F.I.V.A. REV. NO.	STATE	PROJECT NUMBER	SHEET NO.	TOTAL SHEETS
1	MAINE	BR-681P-038-1(35)	169	201

STATE OF MAINE
DEPARTMENT OF TRANSPORTATION
PENOBSCOT RIVER BRIDGE
OVER
PENOBSCOT RIVER
IN THE CITIES OF
BANGOR-BREWER
PENOBSCOT COUNTY
CURTAIN DETAILS

SHEET 40 OF 48 AUGUSTA, MAINE

BRIDGE JOINT SECTION
at Pier No. 1

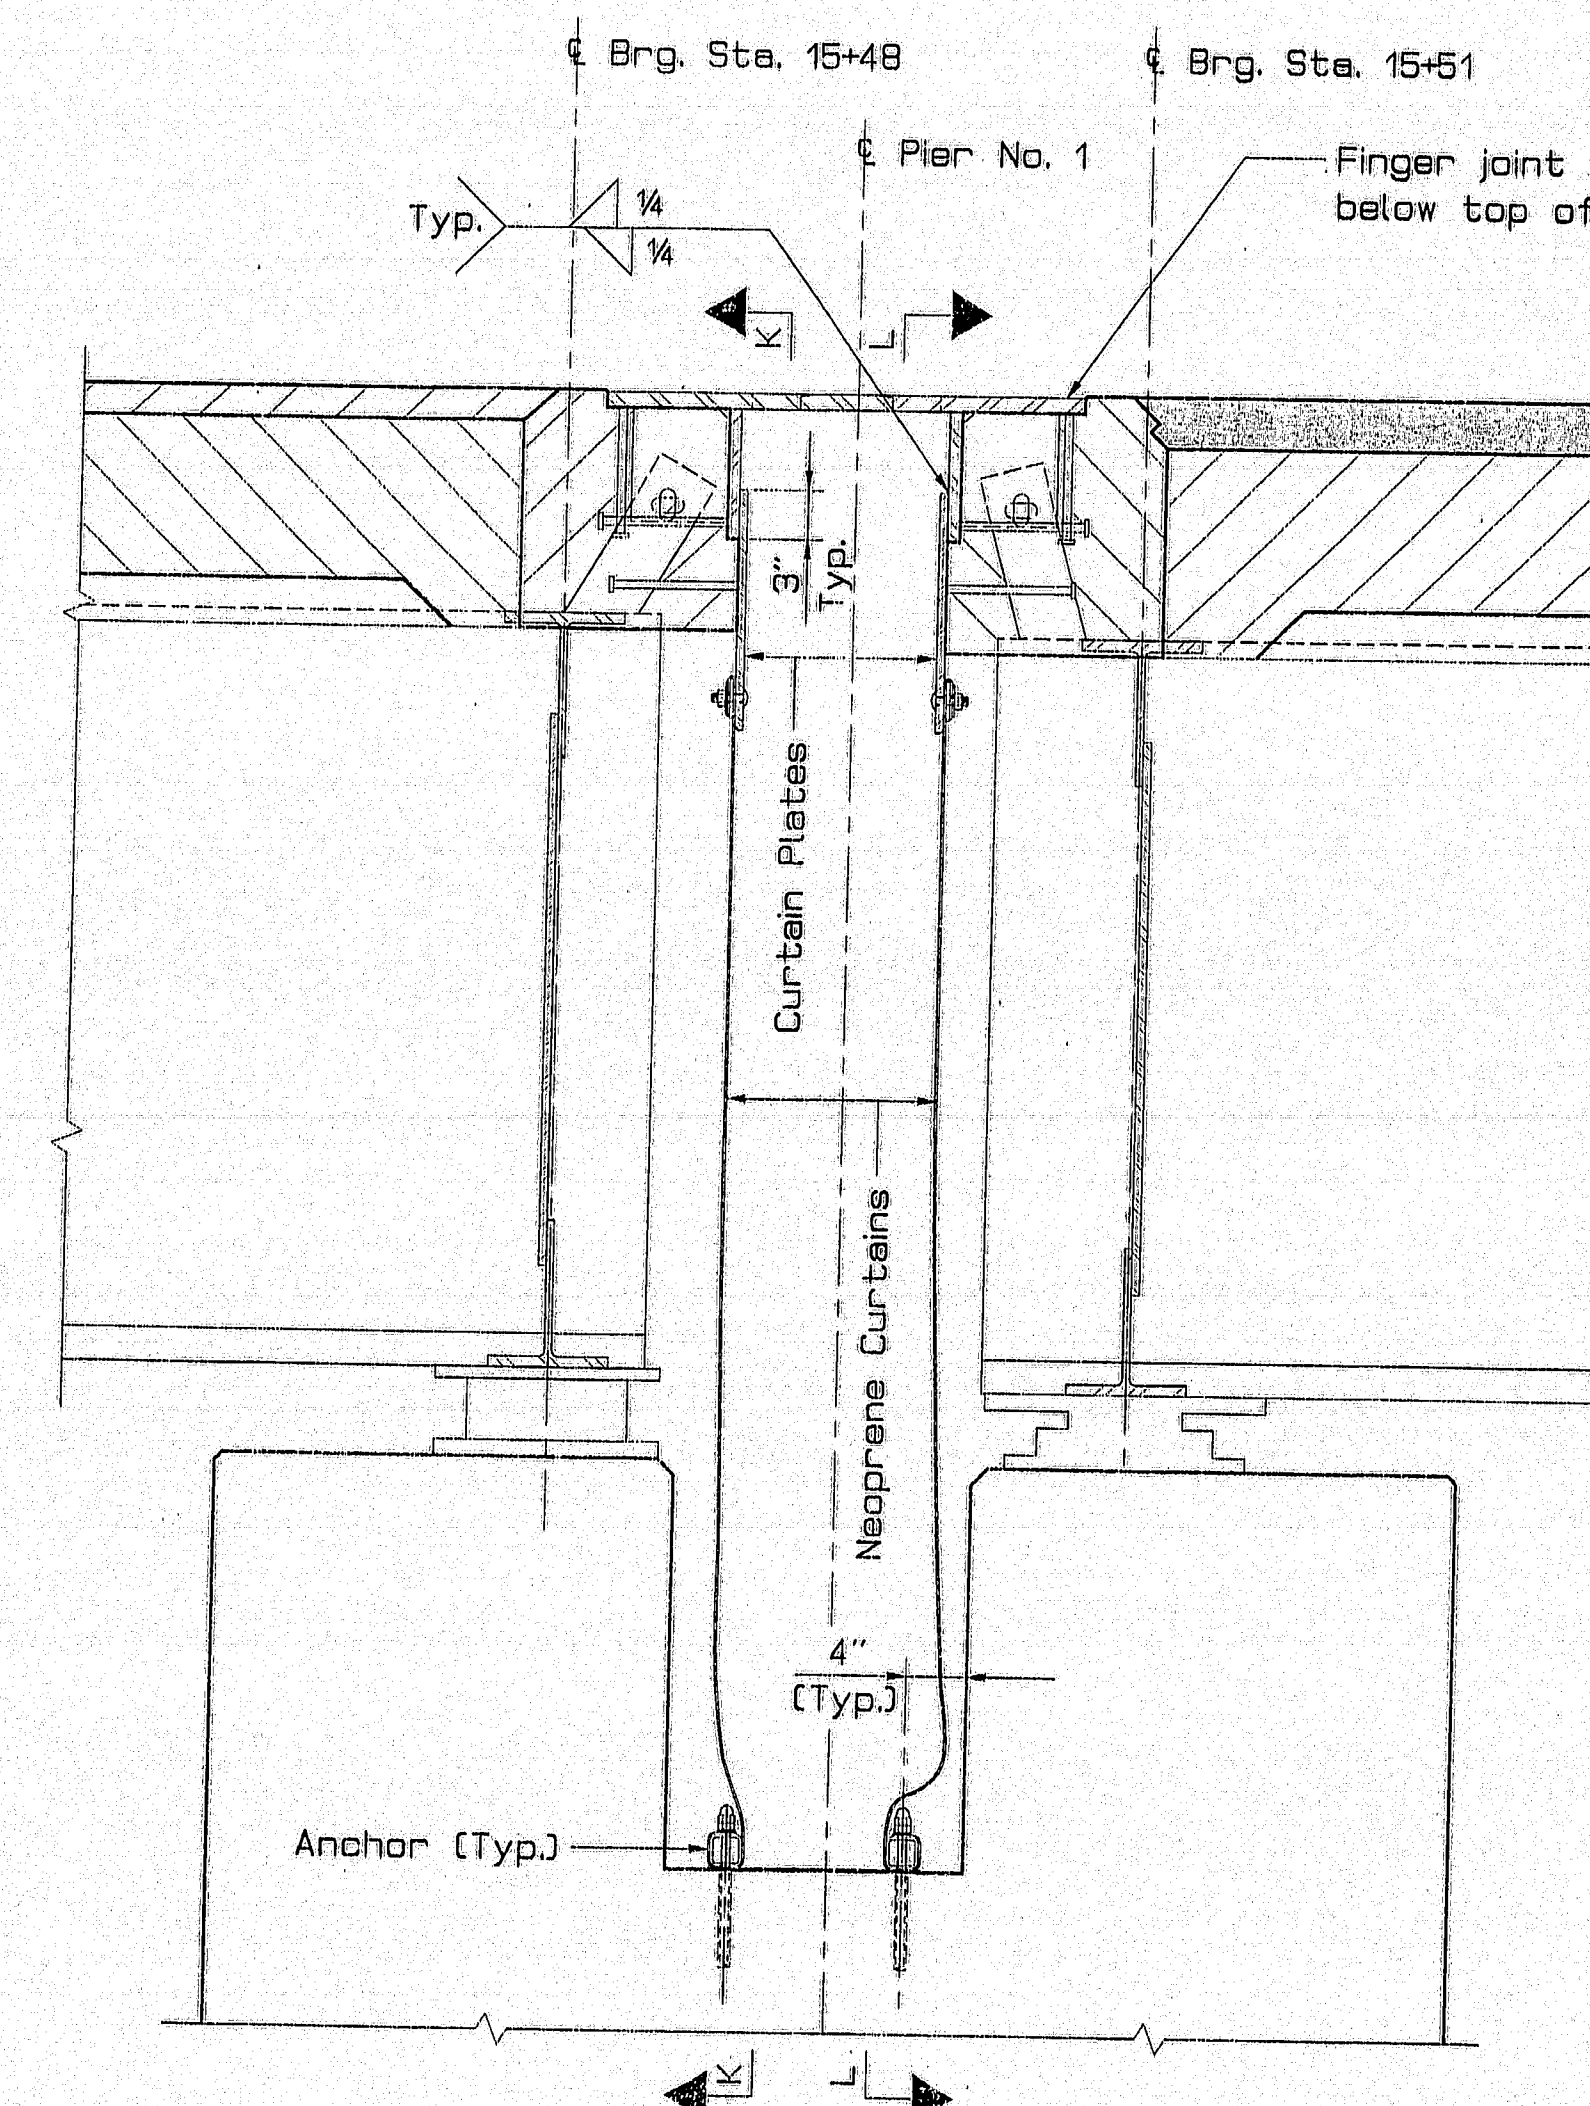
The curtain @ Pier 1
was a bad idea!
As built 1997
